Addendum No. 1

RE: Contract # C204471
WBS # 45446.3.1
FEDERAL-AID NO. NHS-0421(072)
Wilkes County (U-5312)
US-421 FROM EAST OF NC-16 TO US-421 BUS.

The following revisions have been made to the Utility Construction Plans.

LOCATION: US 421 FROM NC 16 TO US 421 BUSINESS IN WILKESBORO
TYPE OF WORK: WATER AND SANITARY SEWER RELOCATION

PROJECT REFERENCE NO.	U-5312	SHEET NO.	UC-22
DESIGNED BY:	B. CLAWSON		
DRAWN BY:	R. MOSS		
CHECKED BY:	B. CLAWSON		
APPROVED BY:			
REVISIED:	5/9/23 11/2/23	MUNICIPAL ENGINEERING SERVICES COMPANY, PA.	
P.O. BOX 97 GARNER, NC 27529 (919) 772-5393		UTILITY CONSTRUCTION PLANS ONLY

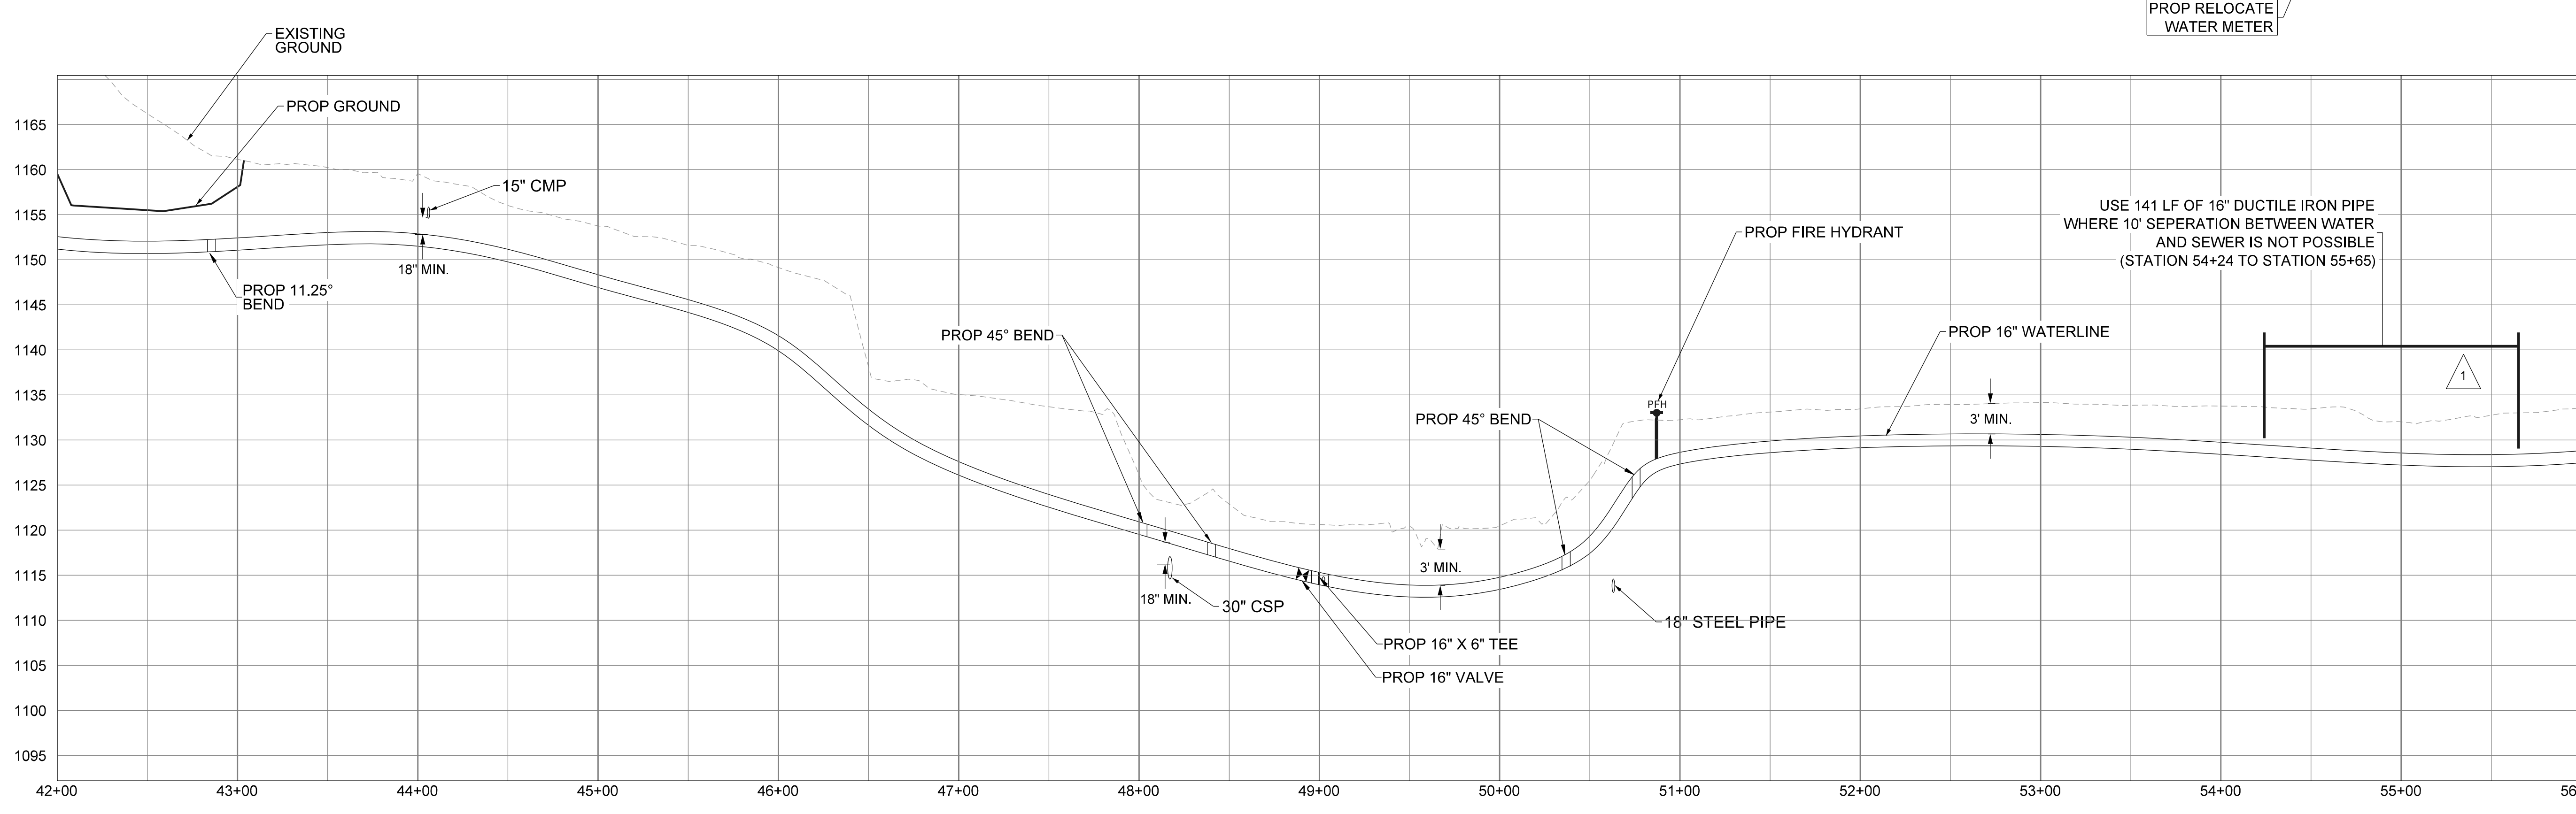
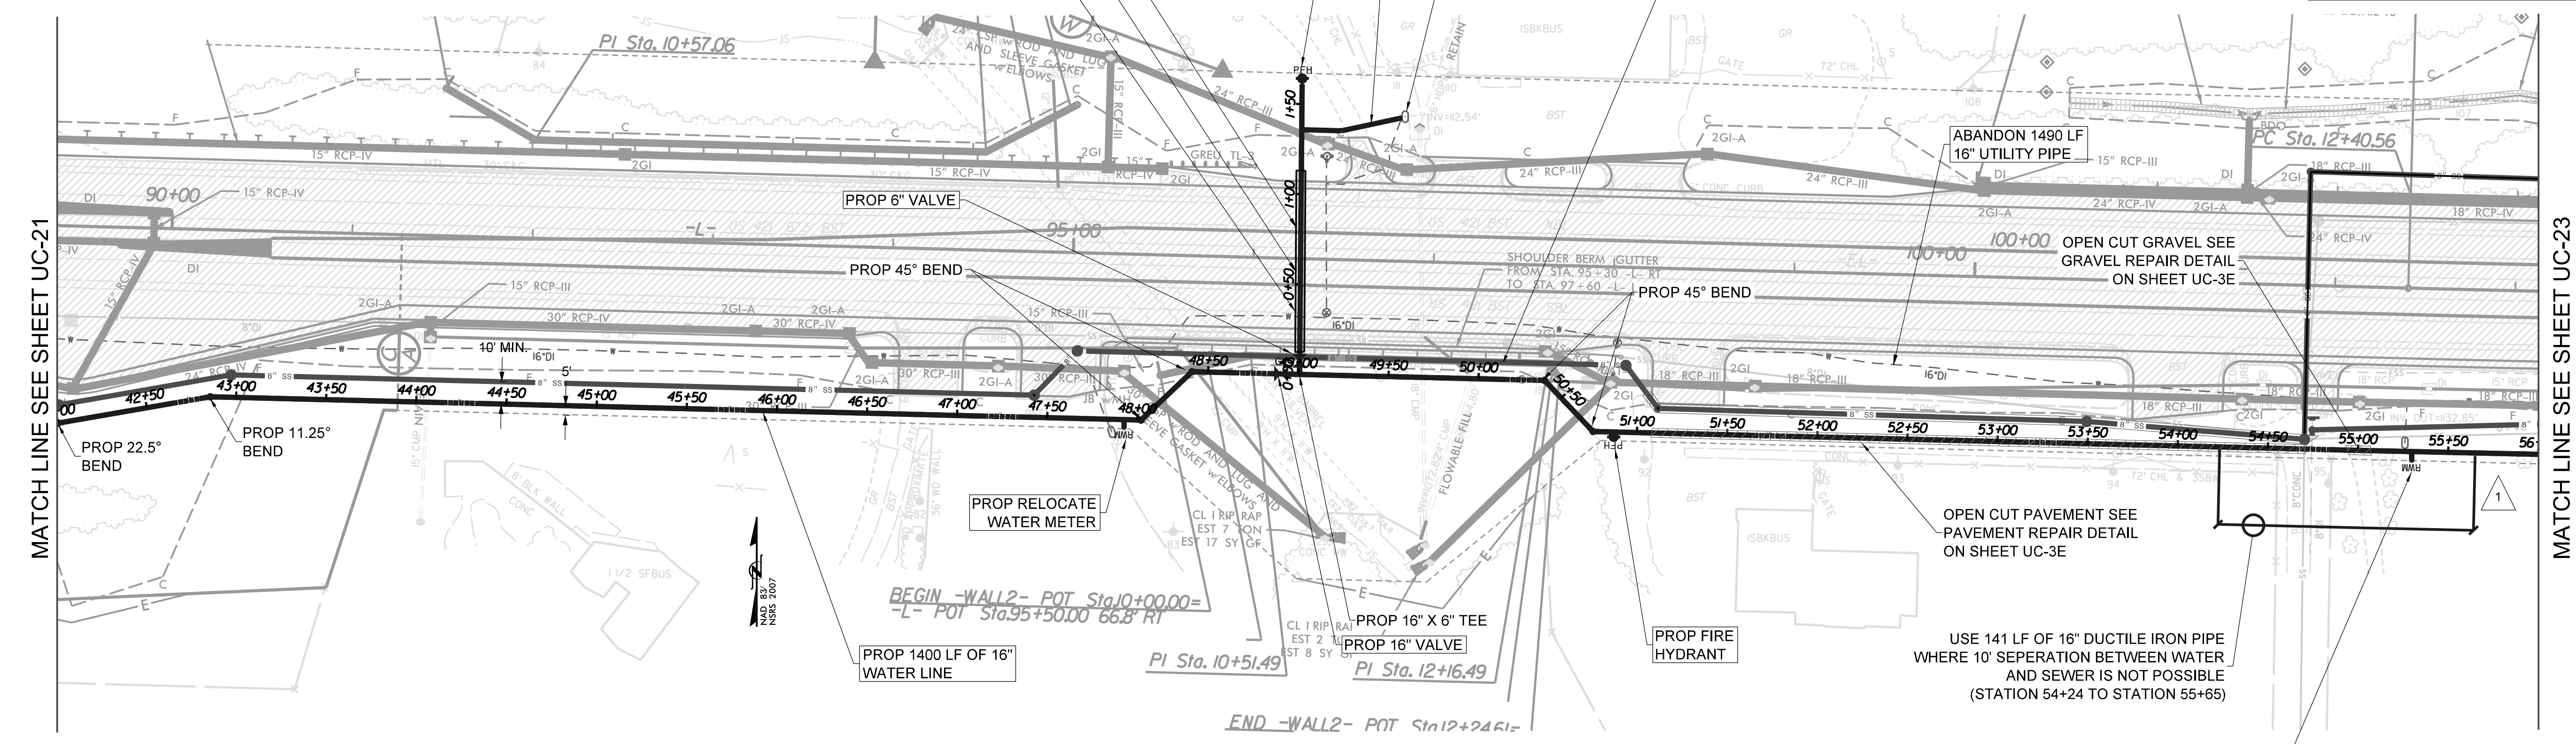
- 1 - ADDED 141 LF OF DUCTILE IRON WHERE 10' SEPERATION ISN'T POSSIBLE.
- 2 - CHANGED NOTE #1

PROJECT REFERENCE NO.	U-5312	SHEET NO.	UC-24
DESIGNED BY:	B. CLAWSON		
DRAWN BY:	R. MOSS		
CHECKED BY:	B. CLAWSON		
APPROVED BY:			
REVISIONS:	5/9/23 11/2/23		
MUNICIPAL ENGINEERING SERVICES COMPANY, PA.	P.O. BOX 97 GARNER, NC 27529 (919) 772-5393	UTILITY CONSTRUCTION PLANS ONLY

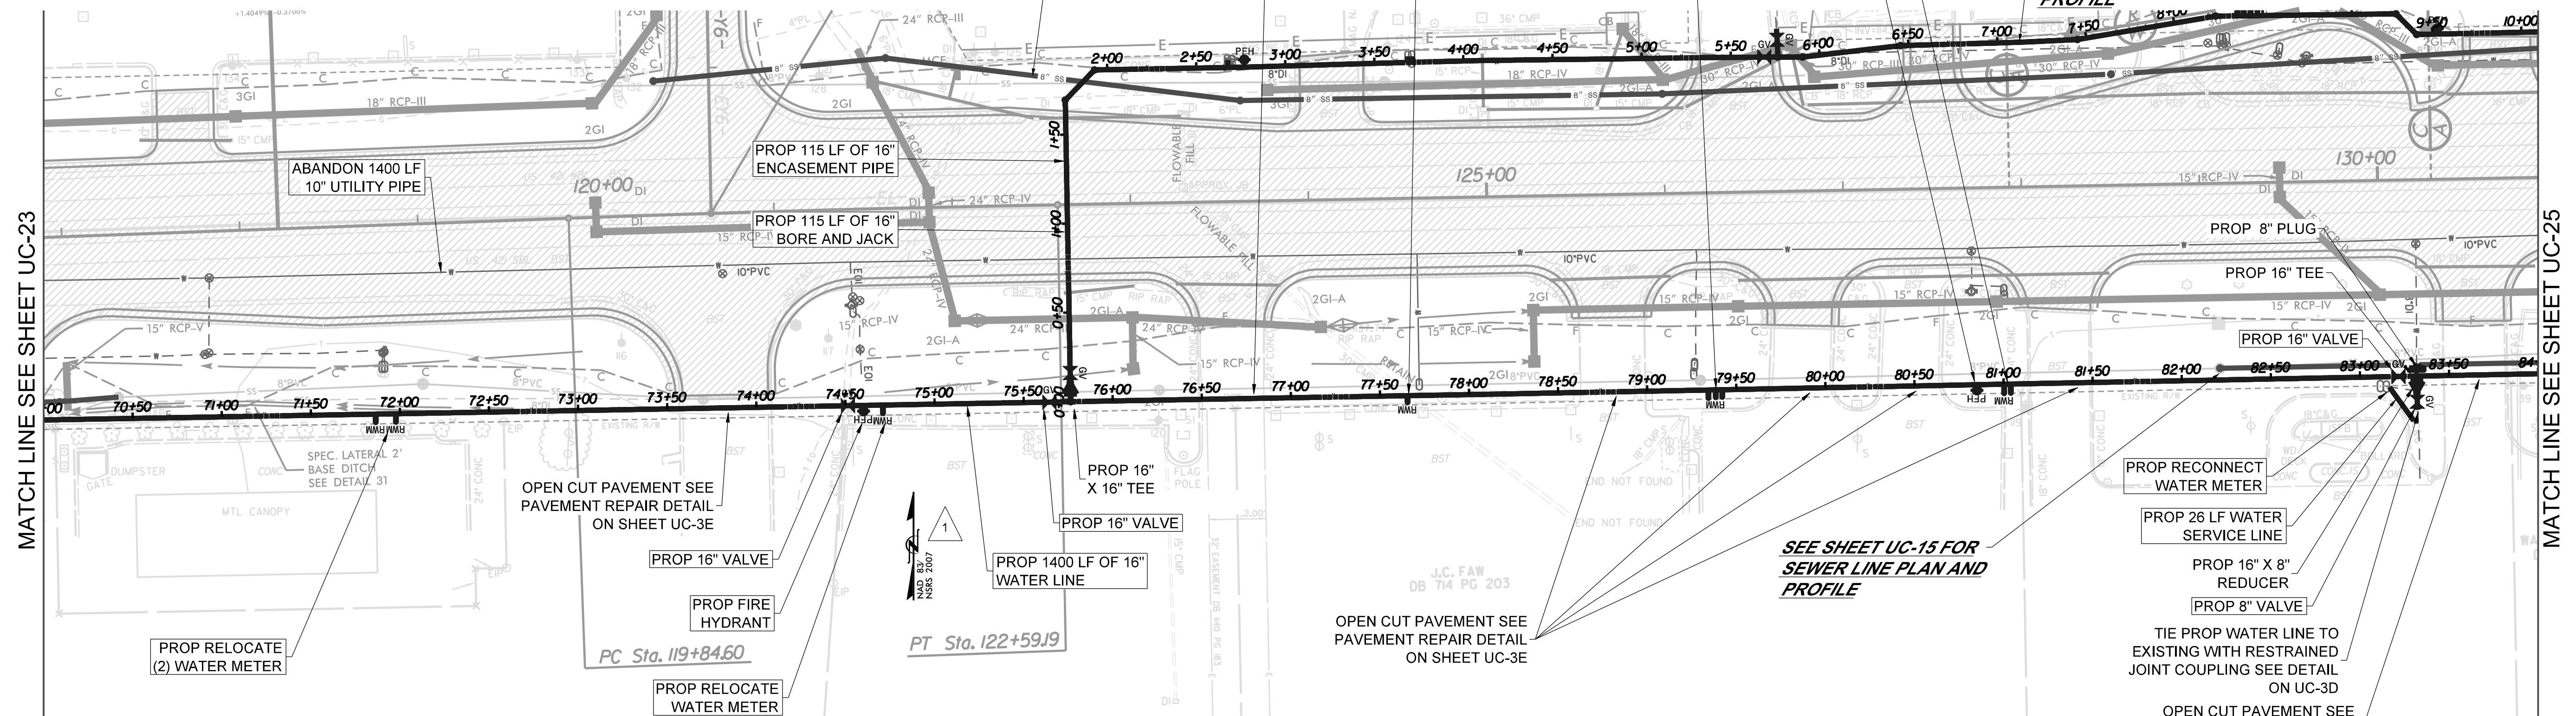
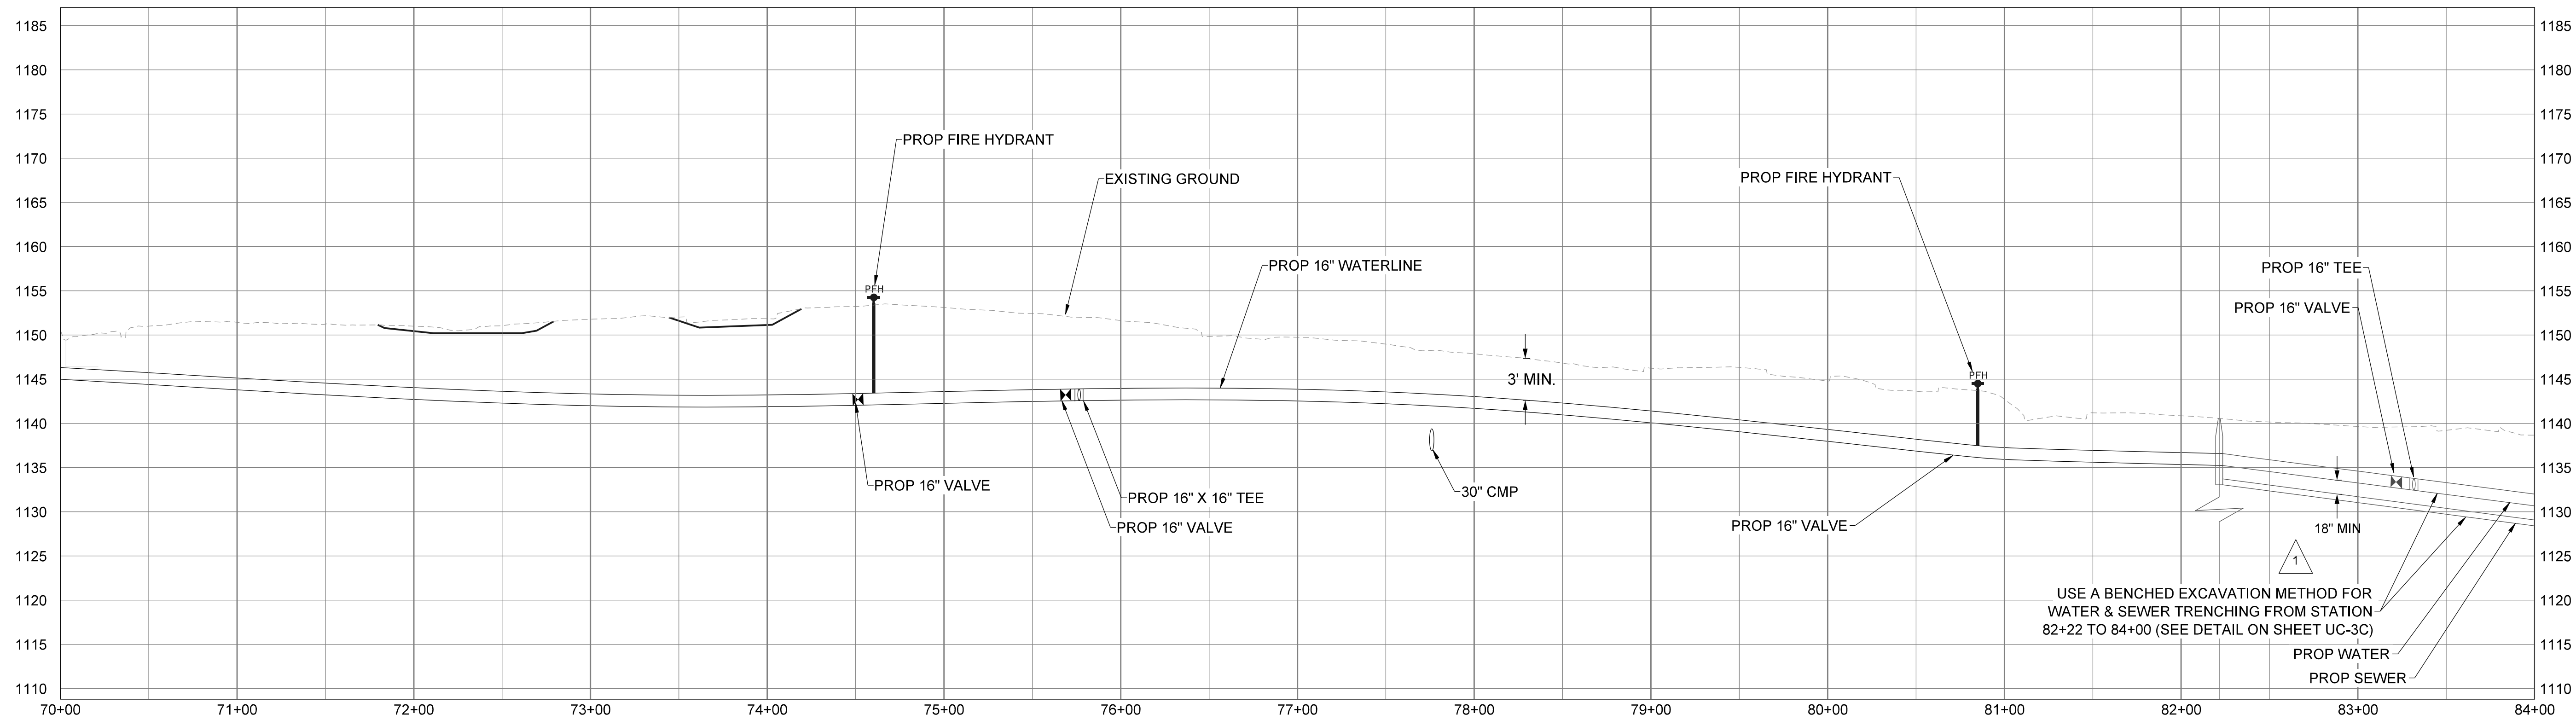
- 1 - ADDED NORTH ARROW
- 2 - PROVIDED MORE DETAIL FOR BENCHED EXCAVATION TRENCHING
- ADDED ELEVATIONS TO PROFILE
- CHANGED NOTE #1

USE A BENCHED EXCAVATION METHOD FOR WATER & SEWER TRENCHING FROM STATION 82+22 TO 84+00 (SEE DETAIL ON SHEET UC-3C)
